Documentation of Public Meeting

FM 2113 Improvements

CSJ: 2060-01-037

FM 2113 from FM 2063 to FM 1695

Blue circle = Property in question

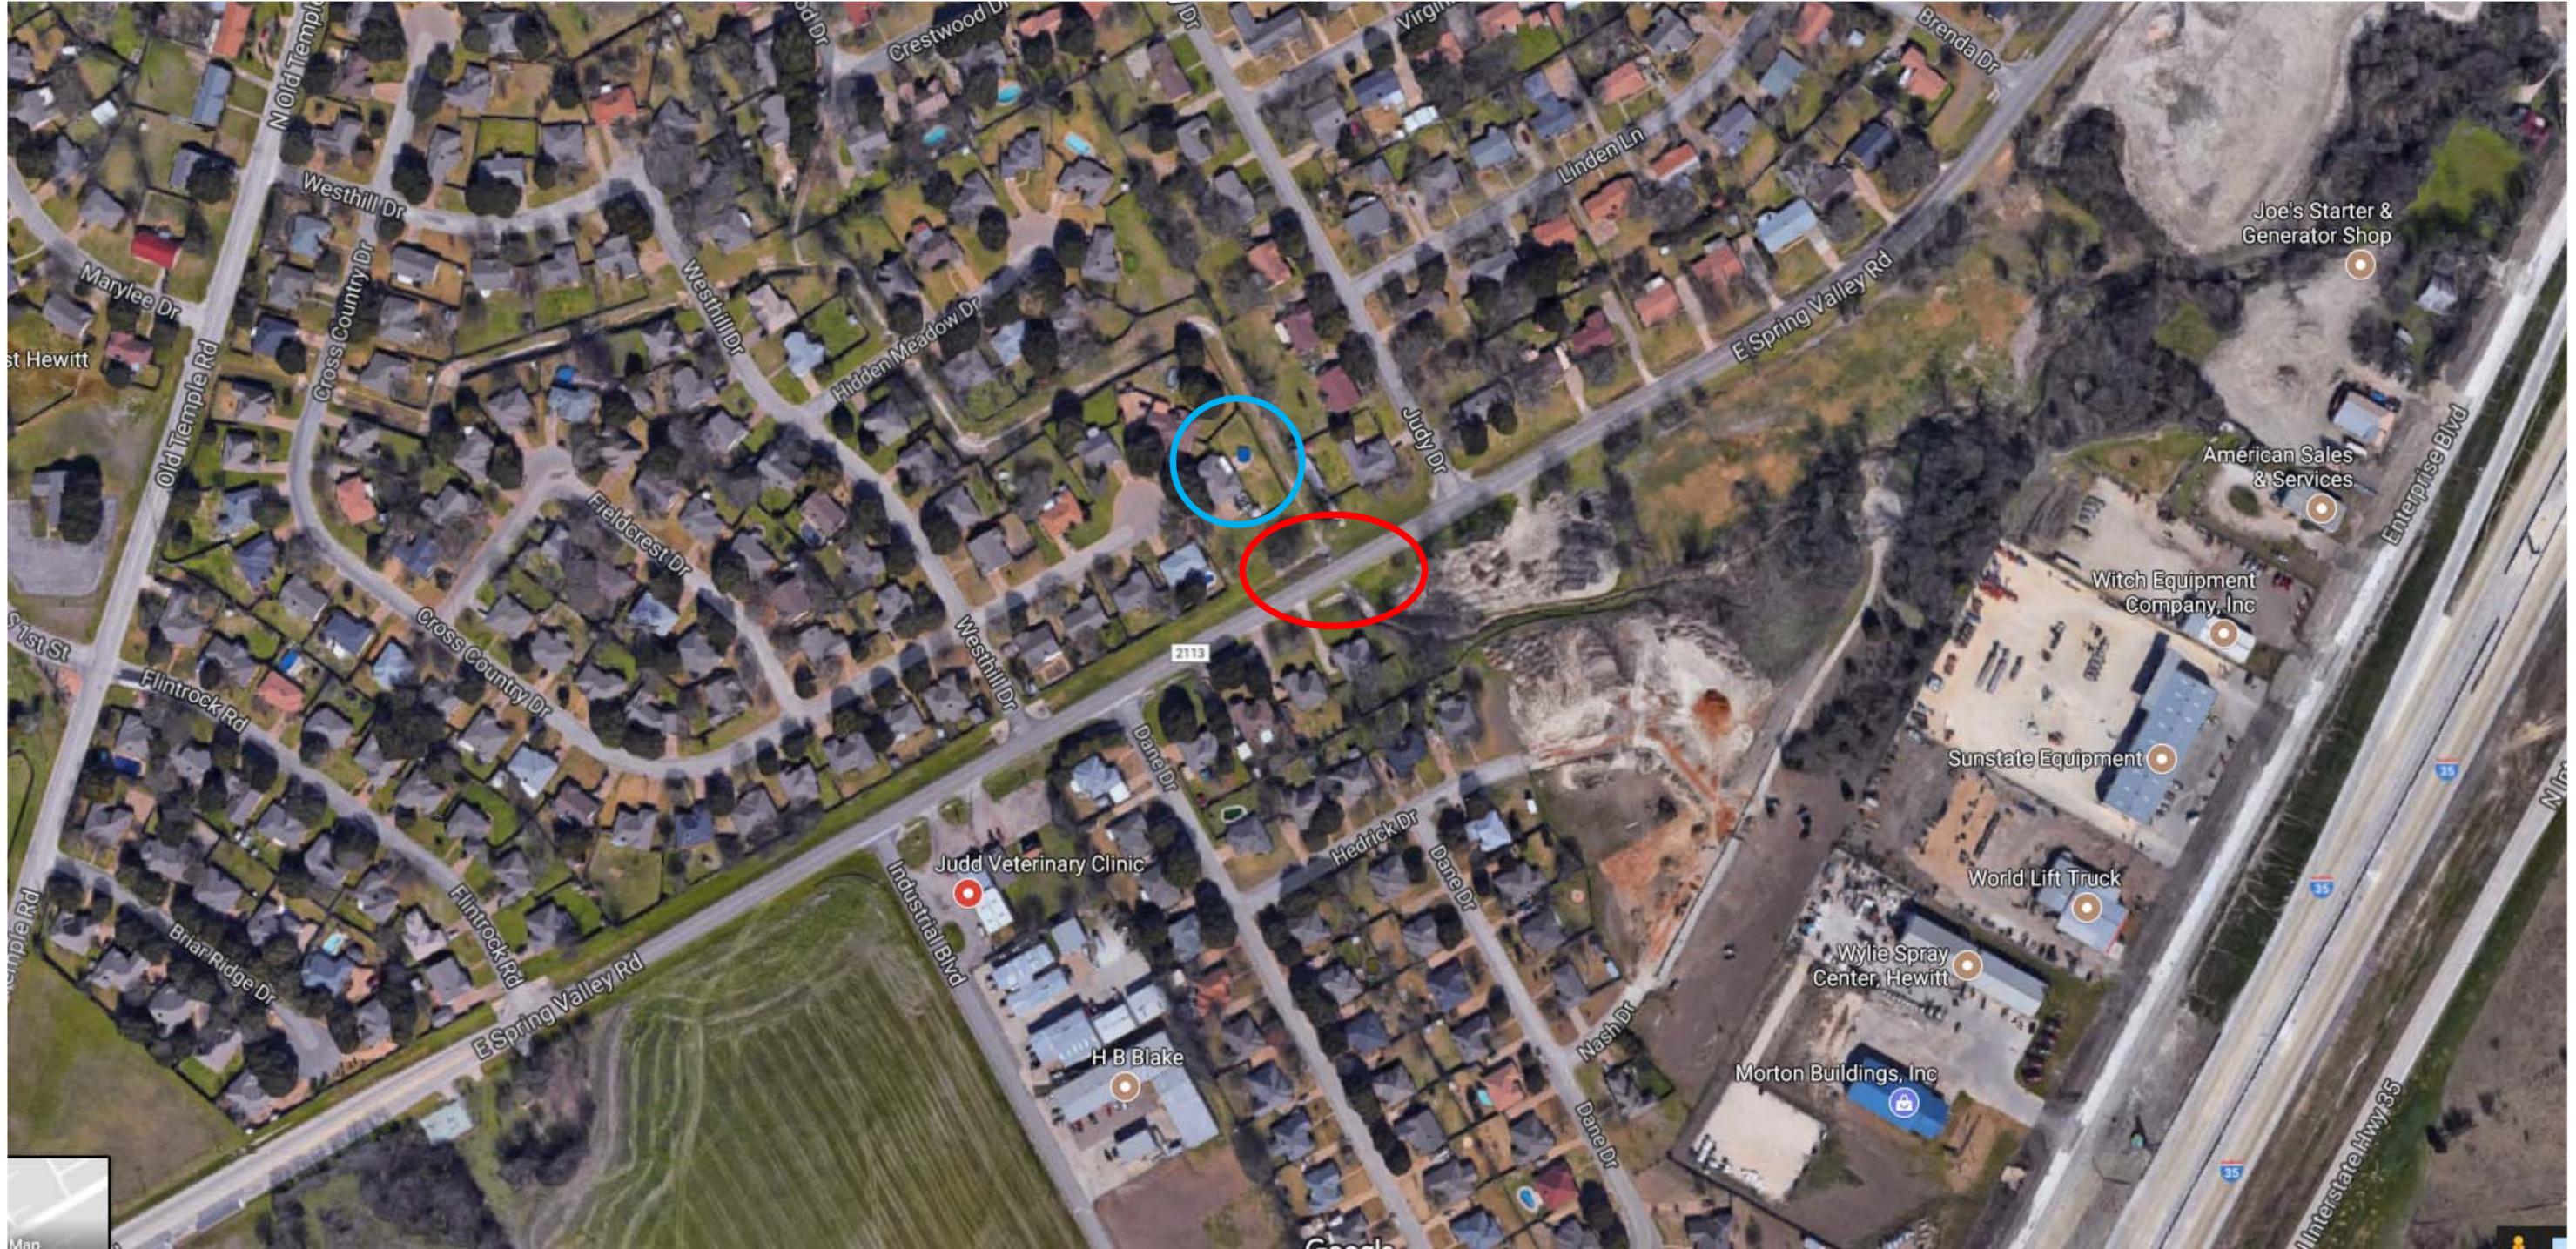
Mark Duncan came in today and said he would likely be unable to make the public meeting on this project but wanted to pass along flooding concerns that they are experiencing. I have additional details as necessary, but I am guessing more folks will bring it up at the public meeting as well.
